Duane Arnold Energy Center
Docket No. 50-331
Renewed Facility Operating License No. DPR-49

License Amendment Request (TSCR-146): Application to Revise Technical Specifications to Adopt Technical Specifications Task Force (TSTF) Traveler-523, "Generic Letter 2008-01, Managing Gas Accumulation," Using the Consolidated Line Item Improvement Process

**Attachment 2
Duane Arnold
Technical Specifications Changes
Marked Up Pages**

SR 3.5.1.1

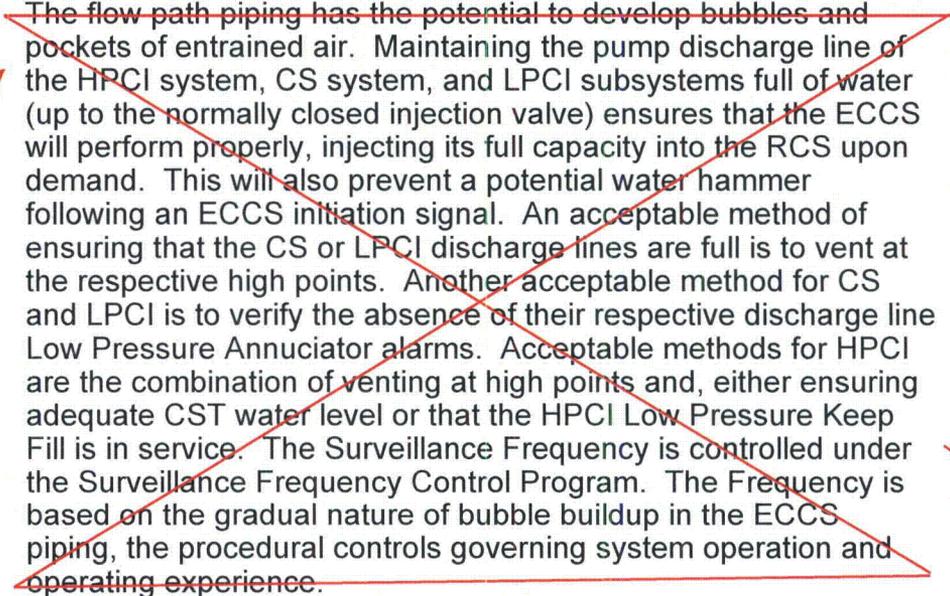
~~The flow path piping has the potential to develop bubbles and pockets of entrained air. Maintaining the pump discharge line of the HPCI system, CS system, and LPCI subsystems full of water (up to the normally closed injection valve) ensures that the ECCS will perform properly, injecting its full capacity into the RCS upon demand. This will also prevent a potential water hammer following an ECCS initiation signal. An acceptable method of ensuring that the CS or LPCI discharge lines are full is to vent at the respective high points. Another acceptable method for CS and LPCI is to verify the absence of their respective discharge line Low Pressure Annunciator alarms. Acceptable methods for HPCI are the combination of venting at high points and, either ensuring adequate CST water level or that the HPCI Low Pressure Keep Fill is in service. The Surveillance Frequency is controlled under the Surveillance Frequency Control Program. The Frequency is based on the gradual nature of bubble buildup in the ECCS piping, the procedural controls governing system operation and operating experience.~~

INSERT 3
next page

Selection of ECCS injection/spray subsystem locations susceptible to gas accumulation is based on a review of system design information, including piping and instrument drawings, isometric drawings, plan and elevation drawings, and calculations. The design review is supplemented by system walkdowns to validate the system high points and to confirm the location and orientation of important components that can become sources of gas or could otherwise cause gas to be trapped or difficult to remove during system maintenance or restoration. Susceptible locations depend on plant and system configuration, such as standby versus operating conditions.

ECCS injection/spray subsystem locations susceptible to gas accumulation are monitored and, if gas is found, the gas volume is compared to the acceptance criteria for the location. Susceptible locations in the same system flow path which are subject to the same gas intrusion mechanisms may be verified by monitoring a representative subset of susceptible locations. Monitoring may not be practical for locations that are inaccessible due to radiological or environmental conditions, plant configuration, or personnel safety. For these locations, alternative methods (e.g., operating parameters, remote monitoring) may be used to monitor the susceptible location. Monitoring is not required for susceptible locations where the maximum potential accumulated gas void volume has been evaluated and determined to not challenge system OPERABILITY. The accuracy of the method used for monitoring the susceptible locations and trending of the results should be sufficient to assure system OPERABILITY during the Surveillance interval.
